PLANNED AREA DEVELOPMENT OVERLAY FOR APACHE ASL TRAILS

PROJECT:
APACHE ASL TRAILS

REV NO.	DATE	
1		PERMIT RESUBMITTAL 04.11.08
2		PERMIT RESUBMITTAL 05.20.08
3		TEMPE COMMENTS 06.11.08
4		CDT PAD AMENDMENT 08.16.08
5		
6		
7

SHEET TITLE:
SITE PLAN, LOCATION PLAN, AND CITY OF TEMPE SITE PLAN CHECKLIST

1 SITE PLAN
SCALE: 1" = 30'-0"

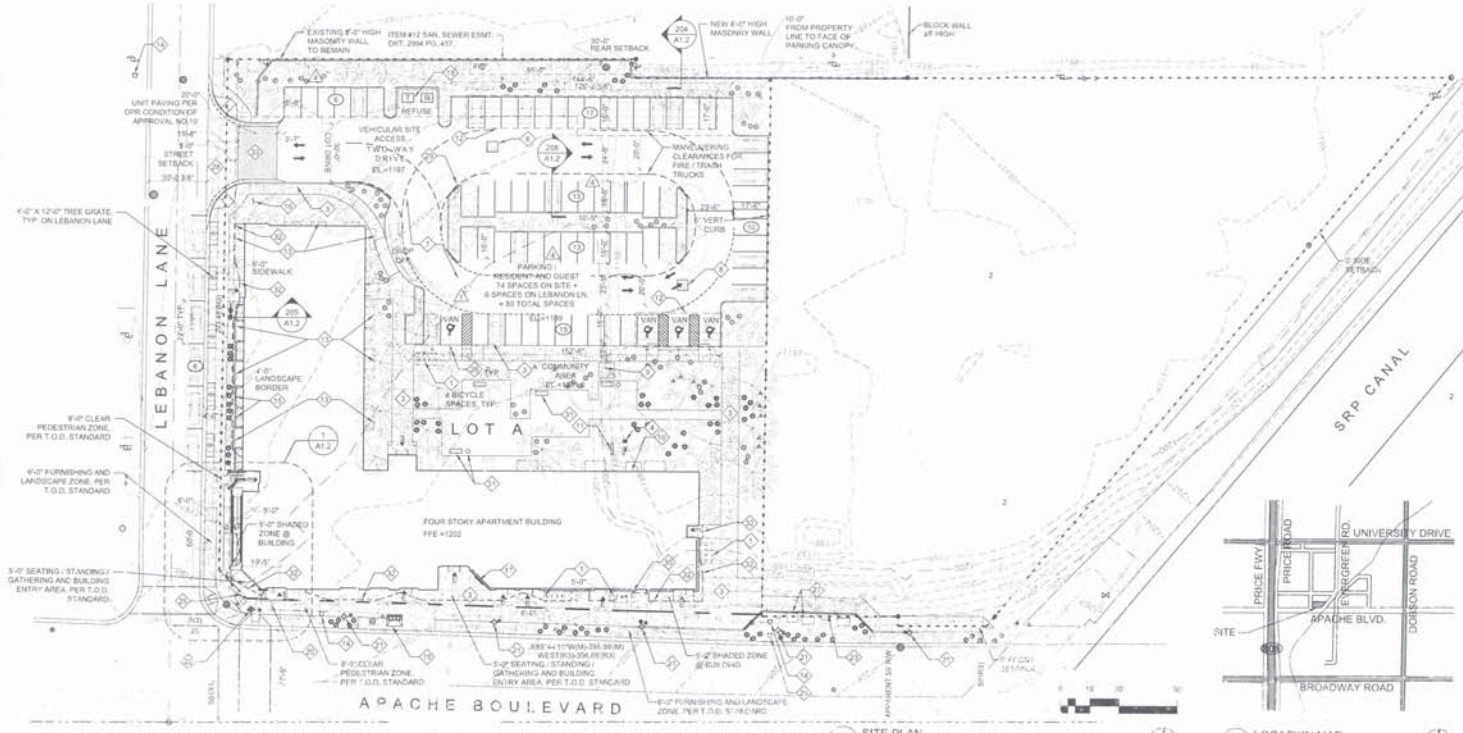
2
1. REVISED CITY OF TEMPE CHECKLIST.
2. REVISED KEY NOTES.
3. ADDED LINE TO INDICATE EXTENT OF PATIOS AND BUILDING ABOVE ON SITE PLAN.
4. REVISED LOCATION OF UNIT PAVERS AT DRIVE.

1
1. RELOCATED BIKE PARKING AT SOUTHWEST CORNER OF PARKING LOT.
2. LOCATED ACCESSIBLE PARKING SIGNAGE.
3. REVISED SIDEWALK AT THE CORNER OF APACHE BLVD. AND LEBANON LANE TO ALLOW FOR CLEAR PEDESTRIAN ZONE AROUND SRP EASEMENT.
4. DELETED PARKING CURBS AND REVISED SIDEWALK ALONG SOUTH EDGE OF PARKING LOT.
5. REVISED PROPERTY LINE ALONG APACHE BLVD.
6. ADDED DIMENSION FROM NORTH PROPERTY LINE TO FACE OF PARKING CANOPY.
7. REVISED PRIVATE DRIVE AT LEBANON LANE.
8. LOCATED NEW FIRE HYDRANTS.
9. REVISED CITY OF TEMPE CHECKLIST.
10. REVISED LENGTH OF SEAT WALL ALONG APACHE BLVD.
11. REVISED LEGAL DESCRIPTION.
12. REVISED KEY NOTES.
